SEWAGE DISPOSAL TESTING

MARYLAND STATE DEPARTMENT OF HEALTH

A 09917
 BEAUFORT PARK
 LOT 8 BLOCK F
 EDENTON CT.

RE: Beaufort Park Subdivision
Lot 8, Block F, Plat 2
Edenton Court

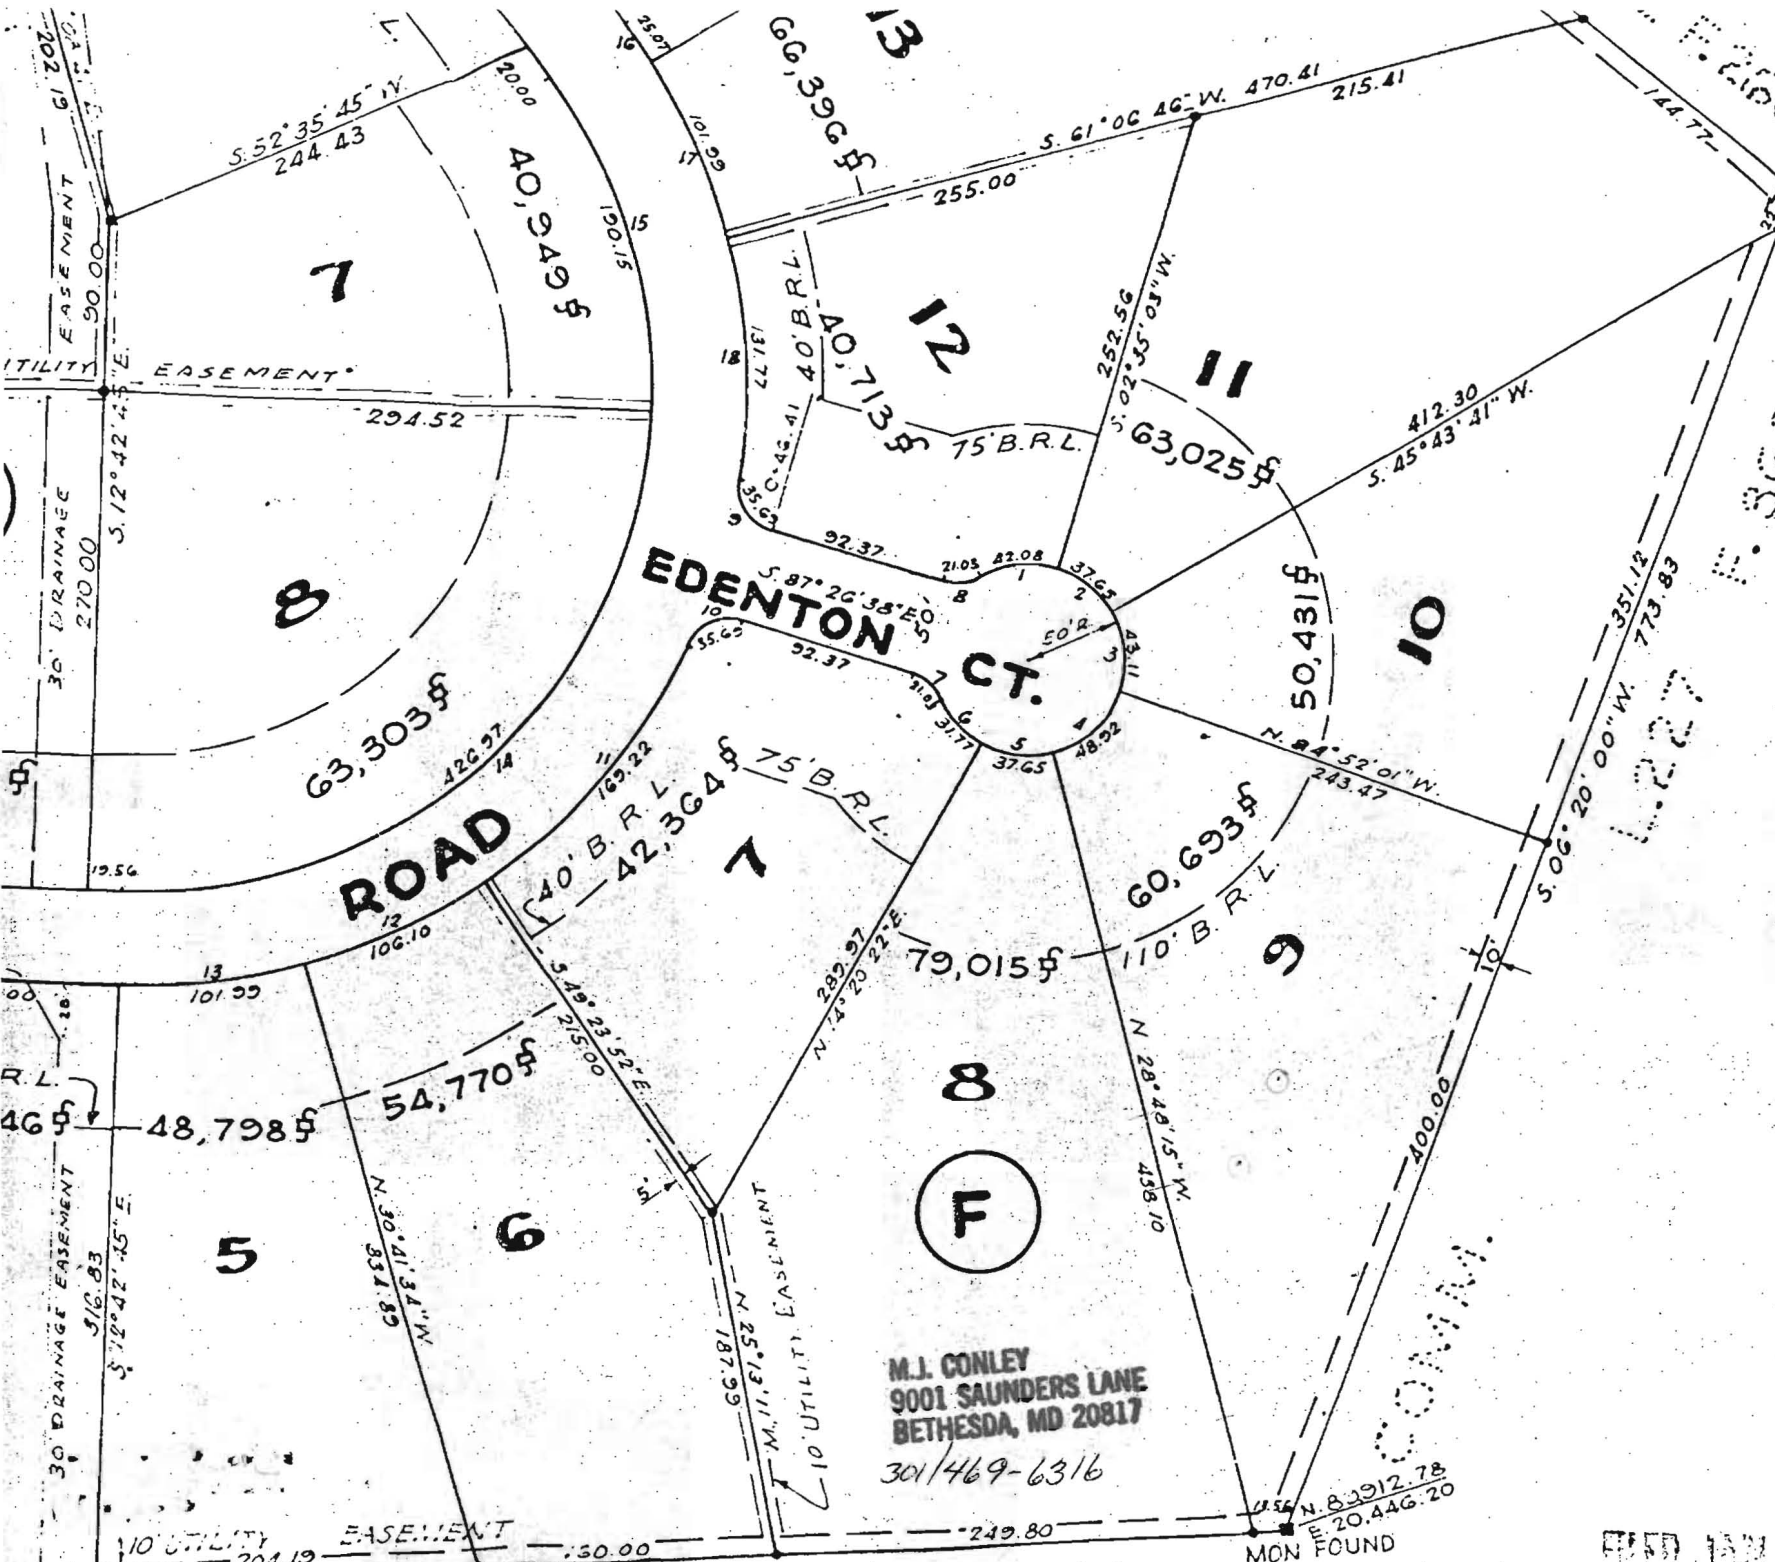
*Please Dry Wells Each Dry Well 150 ft from rear lot line
and with one Dry Well 145 ft from left lot line and second dry well
195 ft from left lot line as seen when facing
lot from Edenton Ct.*

** Dry Wells must be 3x diameter apart edge to edge*

REMARKS shallow dry wells.

Highly wooded lot.
LARGE SWAIL CUTTING ACROSS FRONT OF LOT + CENTER
RISES TOWARD BACK OF LOT, THEN DOWN AT BACK
NEED TO ESTABLISH 10K Φ AREA
OK TO CONFIRM THIS AREA NOW
Holes should be 14' DEEP.
AREA TESTED APPEARS TO BE NEAR ^{S. W. CORNER} HIGHEST PART OF LOT.

REASONS FOR REJECTION OR HOLDING 8-26-88 Repair OK. NO plat NECESSARY

Control on location good. Sab
